**PROPOSED BUILDING COMPRISING 5 APARTMENTS
TREE TOPS HOUSE, GILLOTT'S LANE, HENLEY
APPLICATION P21/S3371/FUL**

Proposed Front Elevation

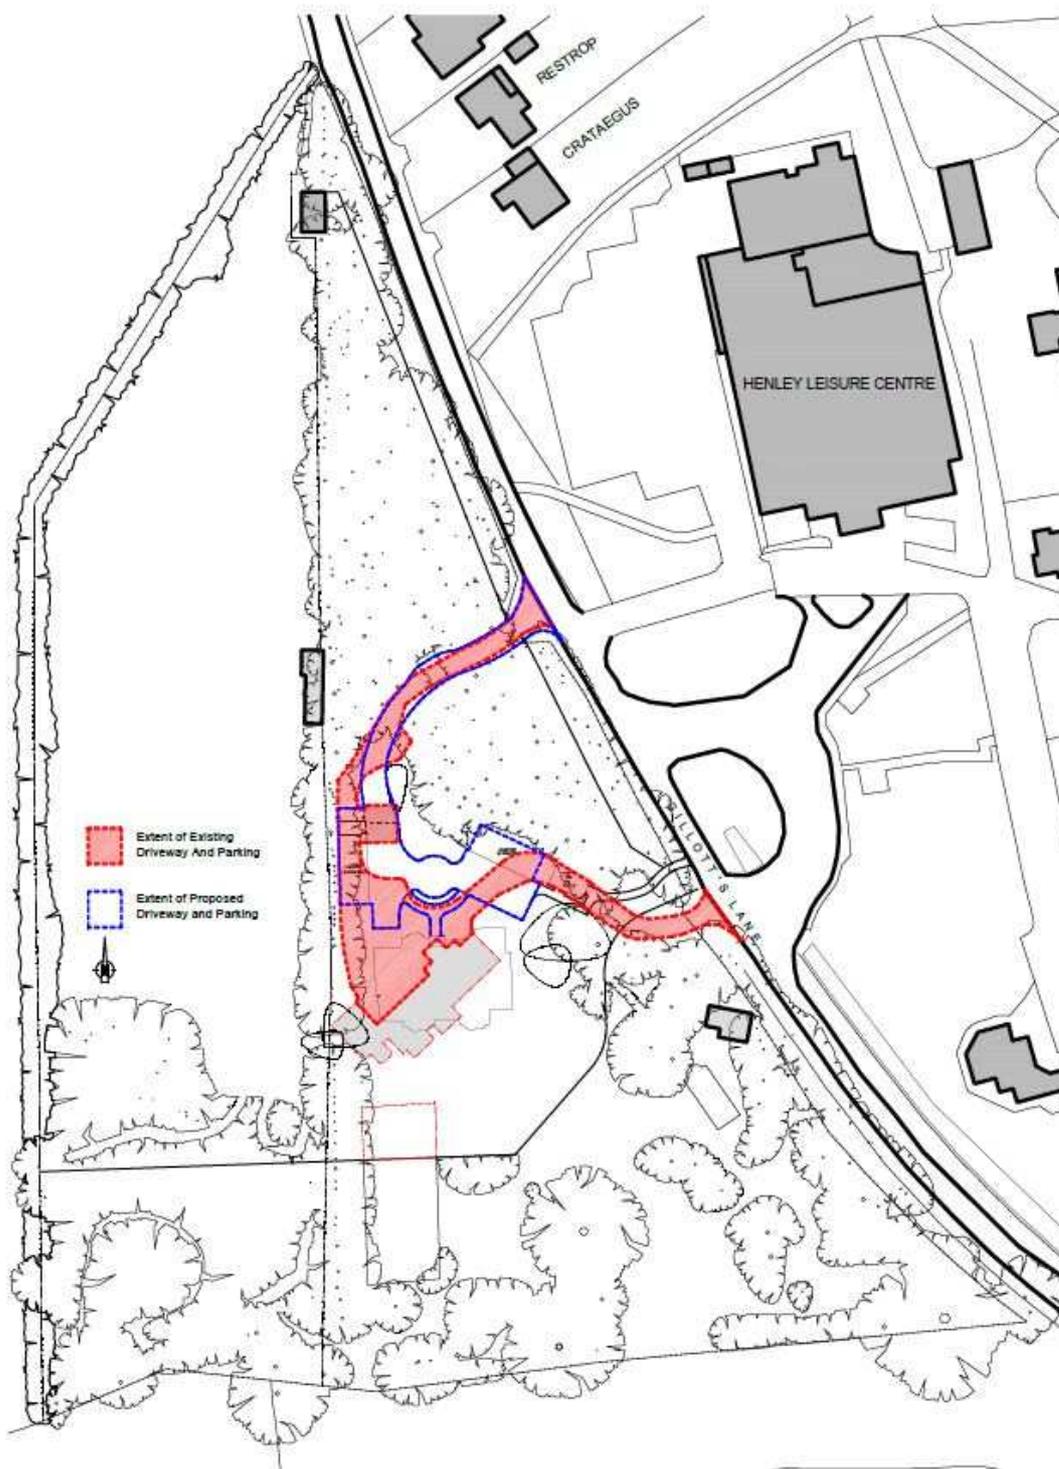
What is an Arts and Crafts style building?

How does the proposed driveway and parking compare to the existing driveway and parking?

The original Tree Tops House was itself an example of late Arts and Crafts design. The proposal embraces this local influence and provides a building of similar scale and character. See a photograph of Tree Tops House and the proposed front elevation below. This approach complies with the SODC Design Guide.

The proposed gravel driveway and parking area has been intentionally located in the same areas as the existing, particularly with regards to its proximity to the boundaries. All residents will also have the use of two Oak frame car port spaces. See the following plan.
